IN THE DRAWINGS:

This amendment is in response to the Office Action of April 6, 2006.

Serial No. 10/791,191

Fig. 5A

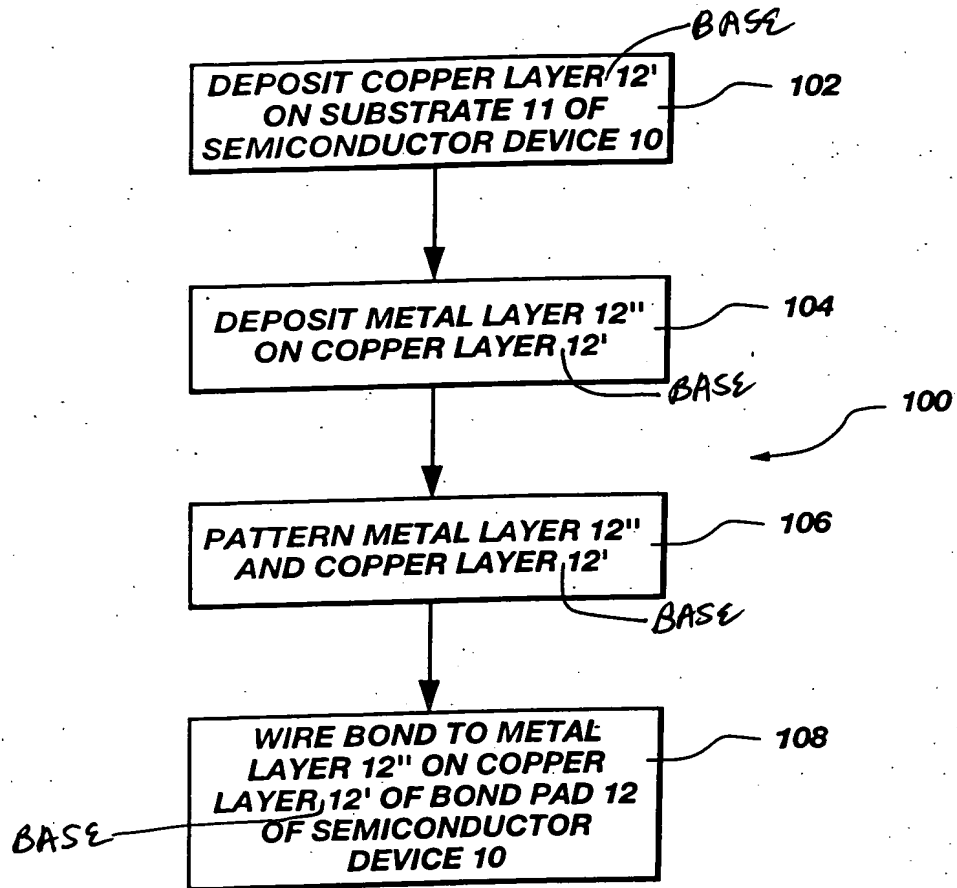
Specifically, FIG. 5A has been revised to insert the word **--BASE--** after the word **--LAYER--** and before the reference numeral **--12'--** on the first line of box 102, second line of box 104, second line of box 106 and third line of box 108; FIG. 5B has been revised to insert the word **--BASE--** after the word **--LAYER--** and before the reference numeral **--12'--** on the second line of box 204, second line of box 206, and third line of box 208; FIG. 5C has been revised to insert the word **--BASE--** after the word **--LAYER--** and before the reference numeral **--12'--** on the first line of box 302, second line of box 304, second line of box 306, second line of box 308 and third line of box 312; FIG. 5D has been revised to insert the word **--BASE--** after the word **--LAYER--** and before the reference numeral **--12'--** on the first line of box 402, second line of box 404, first line of box 408, and third line of box 410; FIG. 5E has been revised to insert the word **--BASE--** after the word **--LAYER--** and before the reference numeral **--12'--** on the first line of box 502, second line of box 504, first and fifth lines of box 508, and third line of box 510; FIG. 5F has been revised to insert the word **--BASE--** after the word **--LAYER--** and before the reference numeral **--12'--** on the first line of box 602, second line of box 604, second line of box 606, and fourth line of box 608; FIG. 5G has been revised to insert the word **--BASE--** after the word **--LAYER--** and before the reference numeral **--12'--** on the first line of box 702, first and second lines of box 704, second line of box 706, and fourth line of box 708; FIG. 5H has been revised to insert the word **--BASE--** after the word **--LAYER--** and before the reference numeral **--12'--** on the first line of box 802, second line of box 804, third line of box 806, second line of box 808, and fourth line of box 812; FIG. 5I has been revised to insert the word **--BASE--** after the word **--LAYER--** and before the reference numeral **--12'--** on the first line of box 902, second line of box 904, first line of box 908, and fourth line of box 910; and FIG. 5J has been revised to insert the word **--BASE--** after the word **--LAYER--** and before the reference numeral **--12'--** on the first line of box 1002, second line of box 1004, first and fifth lines of box 1008, and fourth line of box 1010.
